RFQ NUMBER
 DEP13005

| LINE | QUANTITY | UOP | CAT. NO. | ITEM NUMBER | UNIT PRICE | AMOUNT |
|------|----------|-----|----------|---|------------|--------|
| | | | | ***** ADDENDUM NO. 1 ***** | | |

BENHAM GROUP 120-89
ADDENDUM #1

CHANGES TO SCOPE OF WORK AND TYPICALS

| V-DITCHES | |

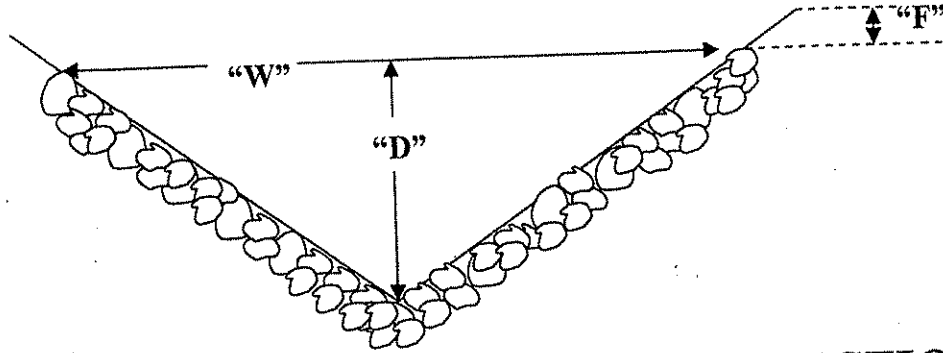
- 12) A new sheet is attached referring to the V-DITCH chart on page 45. The DEPTH "D" of ditches #3, #4, #5, and #6 should be 1' instead of 2'. On the chart, in the note at the bottom, it states that "Ditches #1 and #2 will be standard limestone rip-rap." Delete "#2" from this line and add new line "Ditch #2 will be limestone of 3" to 5" in diameter." (A new typical is attached.)

| GROUTED RIP-RAP CHANNEL/SPILLWAYS | |

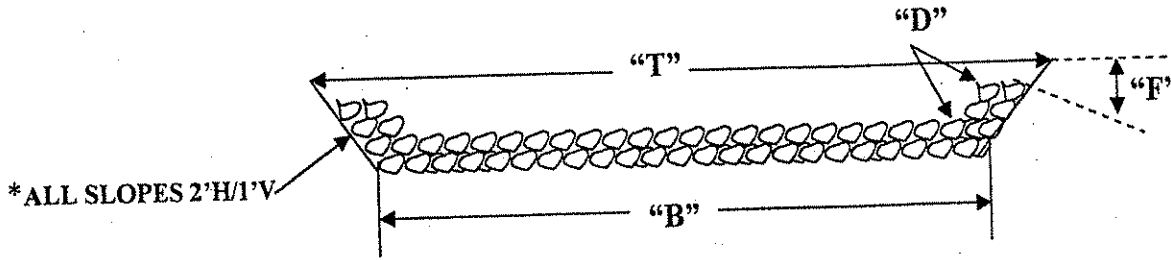
- 20) On page 20, change the second "item 17.3" to "item 17.4".
- 21) On page 48, Channel #4a should be lined with "grouted limestone" rather than "grouted sandstone". (A new typical is attached.)

| SLUDGE CELL #1 X-SECTION | |

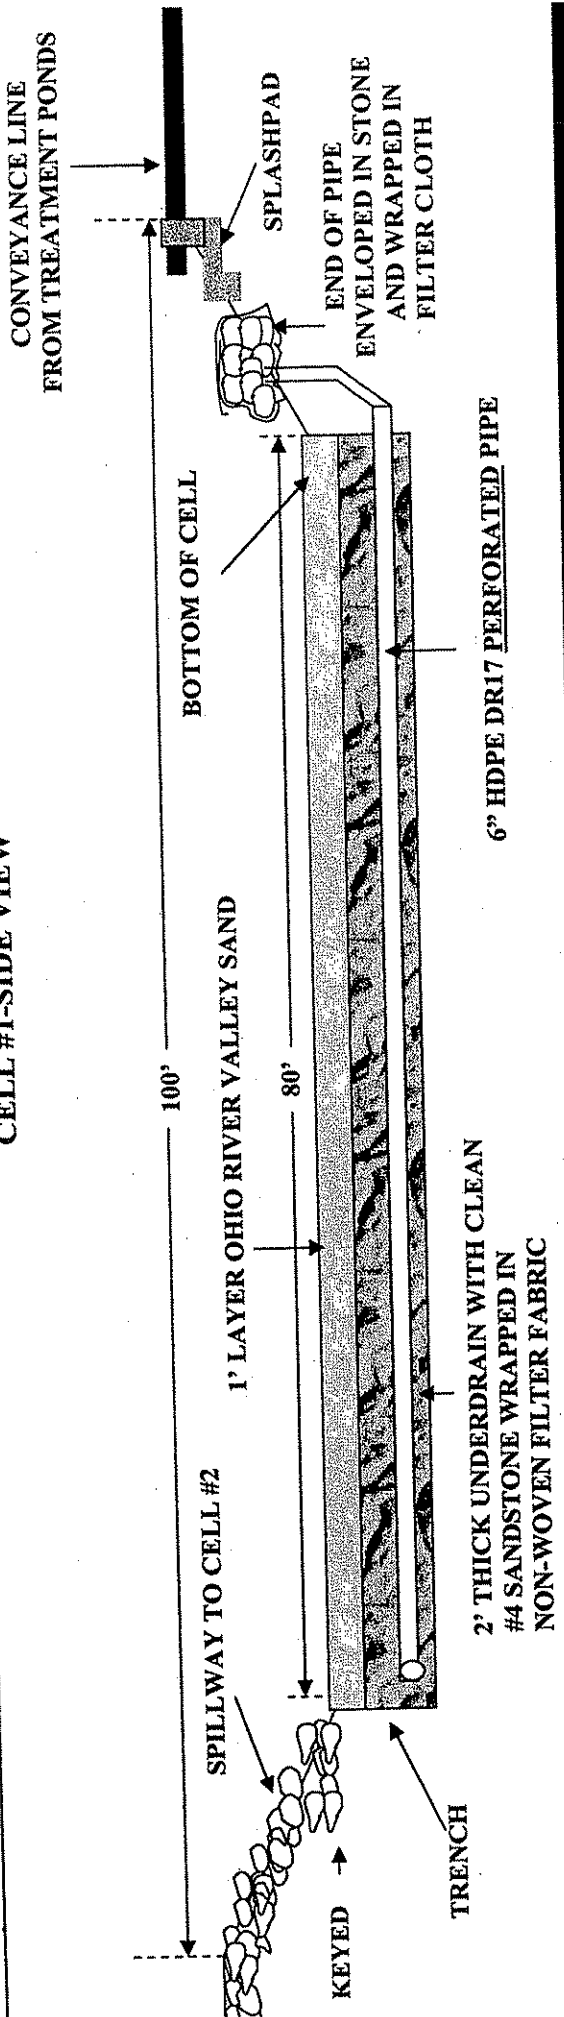
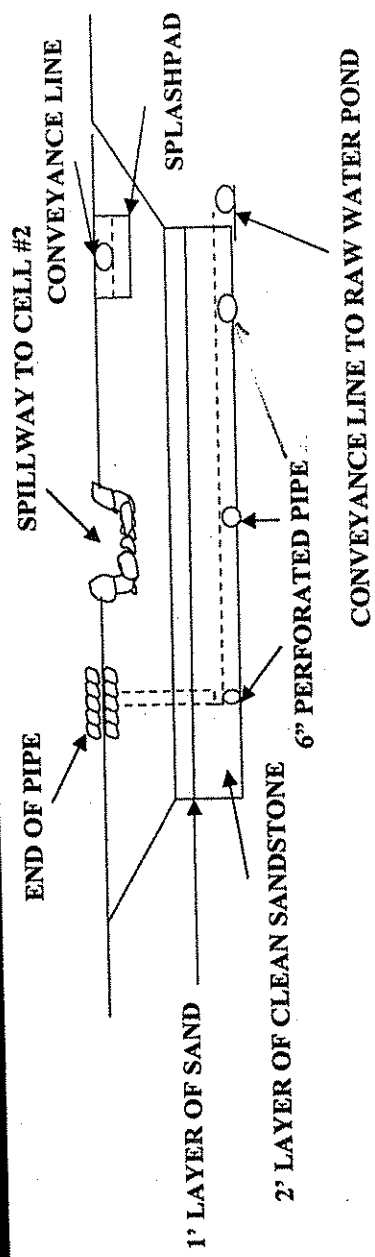
- 8) On page 15, Item #19 refers to ...“entrenched one foot (1') thick layer of”. This item should state that the “complete system of pipes, stone, sand, and fabric will be installed in one trench on the bottom of the drying cell. The typical, SLUDGE CELL#1 X-SECTION, on page 53, has been changed to show this installation. (A new typical is attached.)

| DRYING CELLS TYPICAL | |

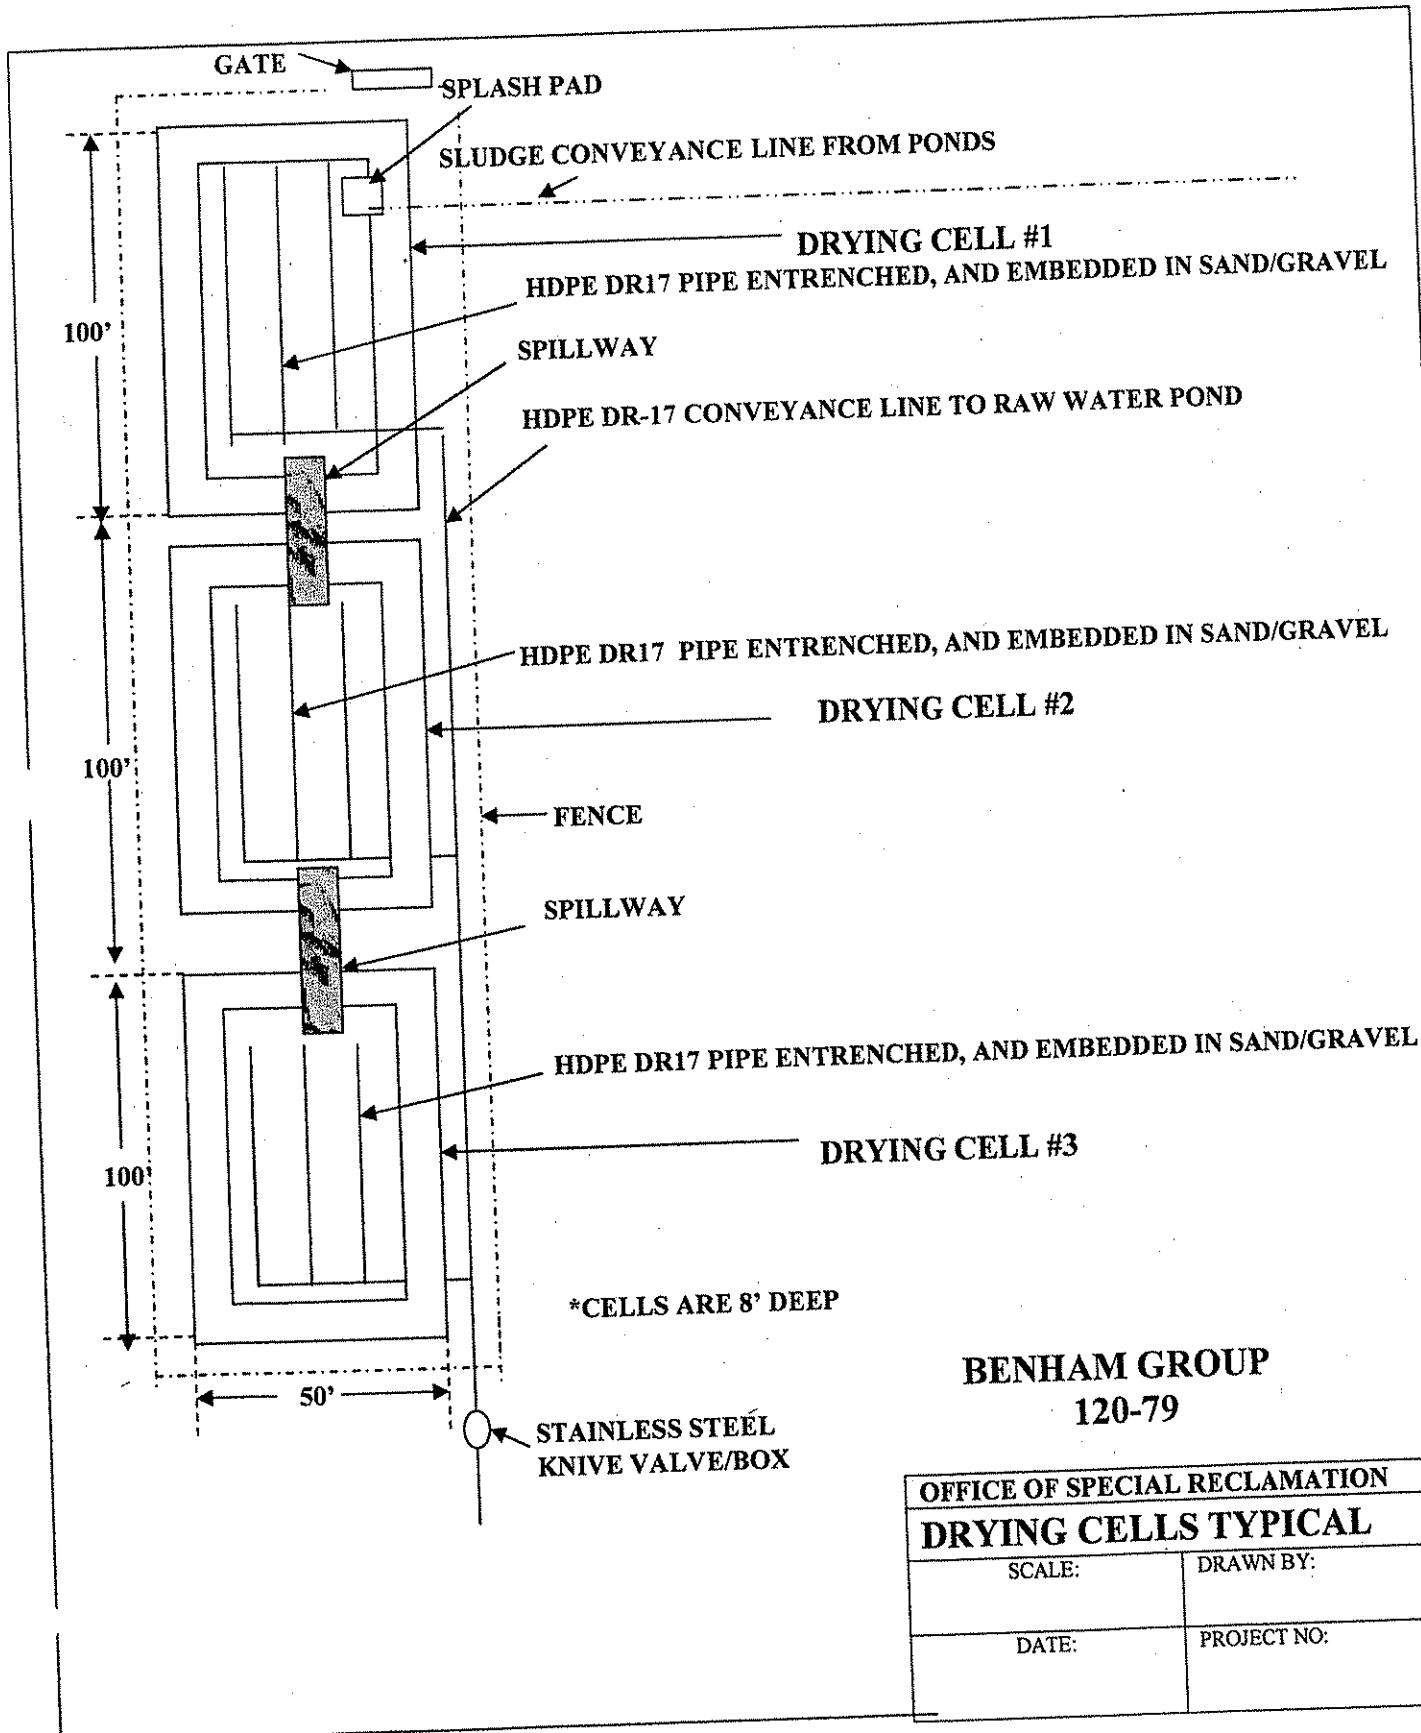
- 9) On page 15, Item #20, change reference ...“SCR 35 perforated underdrain”...to read ...“HDPE DR 17 perforated underdrain. The DRYING CELL TYPICAL, on page 54, has been changed to show the installment. (A new typical is attached.)

| OFFICE OF SPECIAL RECLAMATION SUMP/CULVERT/ALKALINITY CELL #3 | |

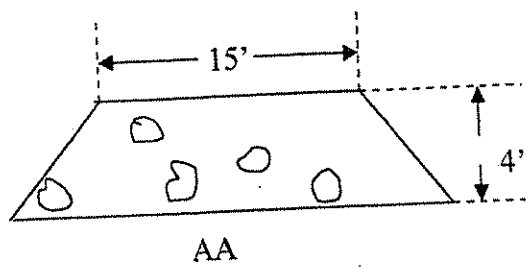
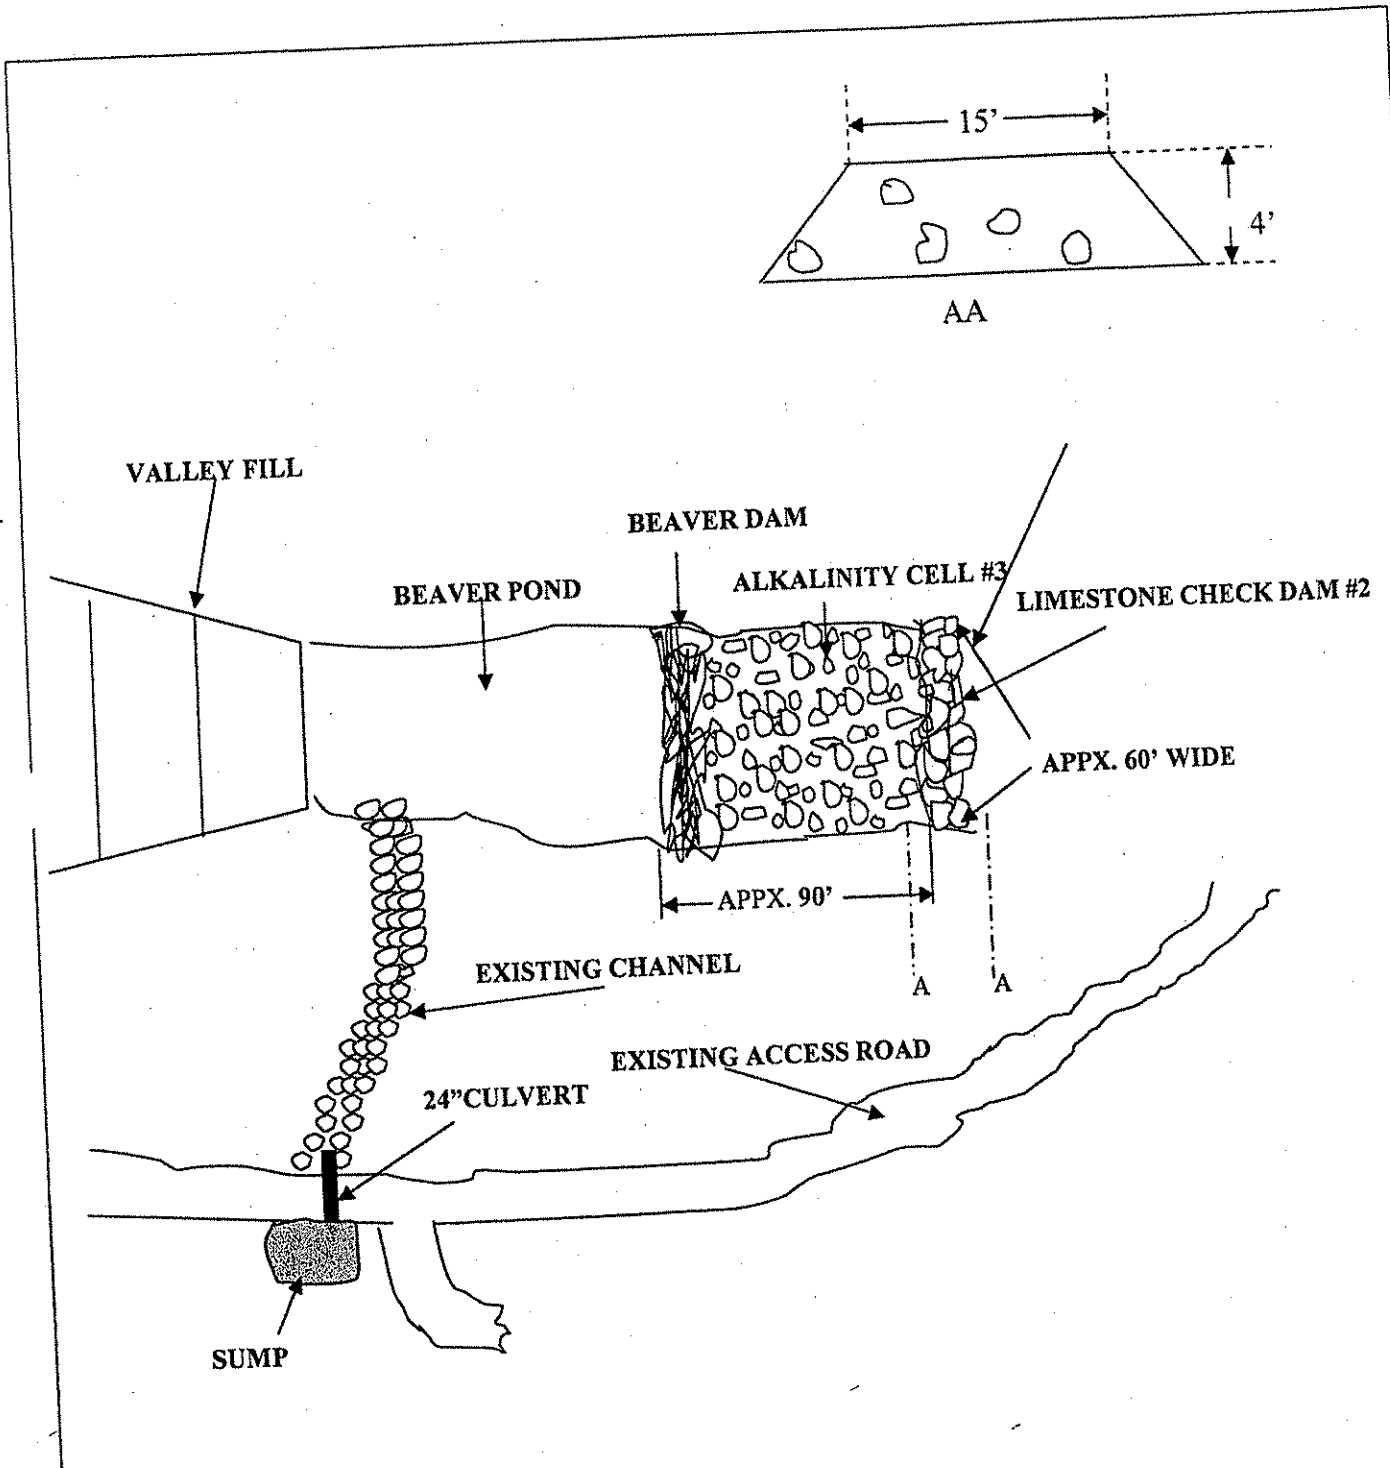
- 22) On page 16, Item #21, remove the lines "Sump will be equipped with a HDPE "Poly-Flex liner with a sixty (60) mil thickness, or equivalent, which shall be fused on site and not leak. The liner shall cover the entire inside of the sump and be anchored in at the top." Also, there will be no reference to cost of the liner on this item. The typical, SUMP/CULVERT/ALKALINITY CELL on page 55, and the SUMP AND 24"

CULVERT typical on page 56, have also been changed to show that the sump will not be lined. (A new typical is attached.)

| RAW WATER POND TYPICAL | |

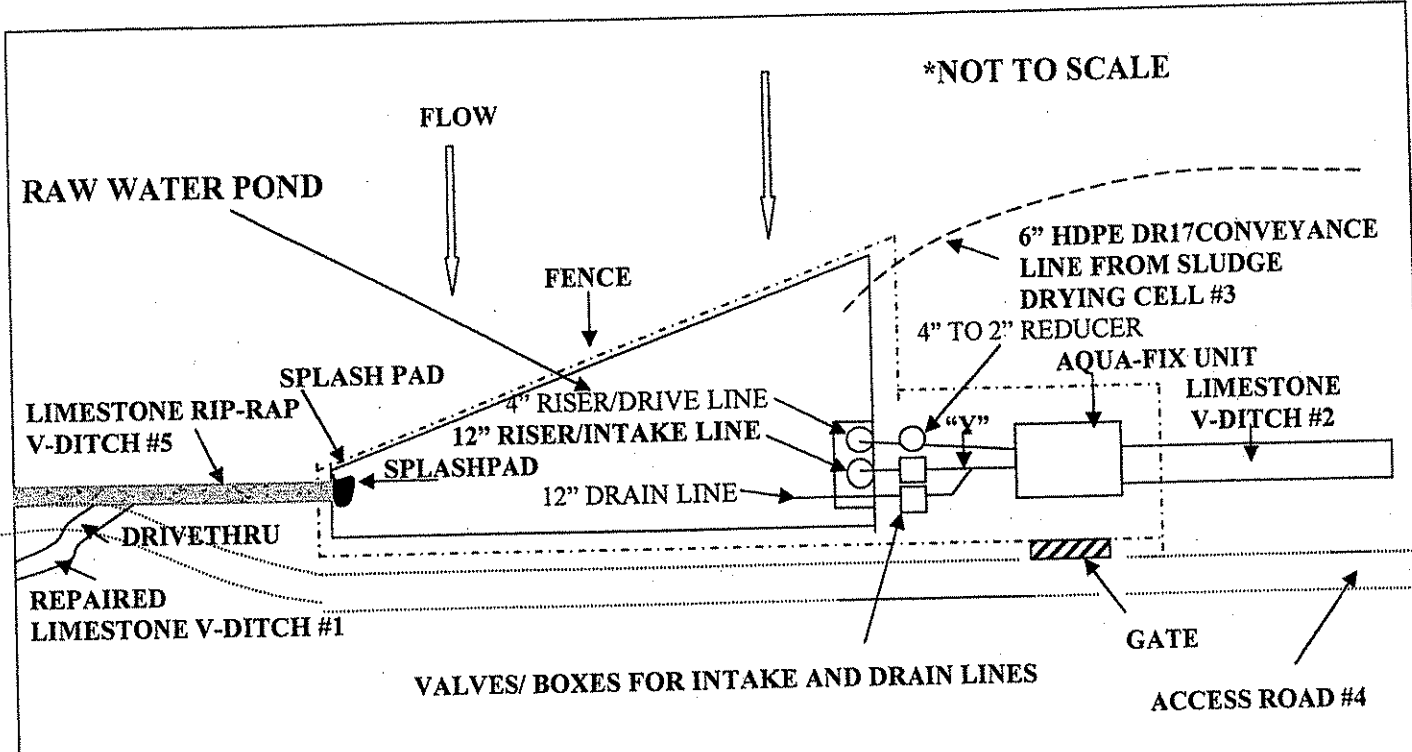
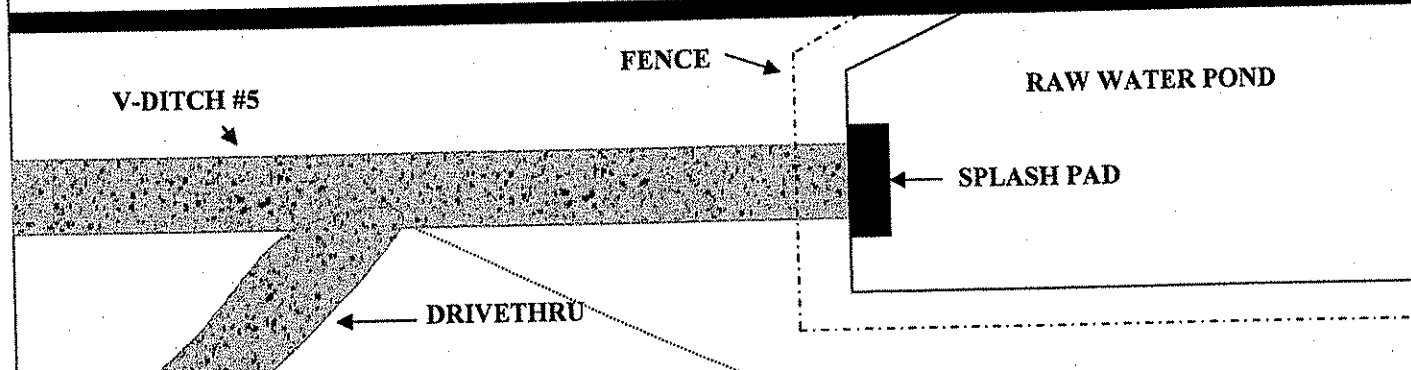
- 7) Page 78, “RAW WATER POND TYPICAL” , and page 79, “RAW WATER POND STAND PIPE ANCHOR PAD TYPICAL”, have been changed to show only two (2) risers and one (1) drain line. Also, on the RAW WATER POND TYPICAL, change “SPLAHPAD” to read “SPLASHPAD”. On the RAW WATER POND STAND PIPE ANCHOR PAD TYPICAL, change.... “ONE 12” AND ONE 4” SCHEDULE 40 PVC RISERS” HDPE DR17 RISER ...to read ...ONE 12” HDPE DR 17 RISER AND ONE 4” PVC RISER”. Note that the typical also shows the dike wall continuing past the anchor pad and the rebar in the anchor pad is shown to run horizontal as well as vertical. (New typicals have been attached.)
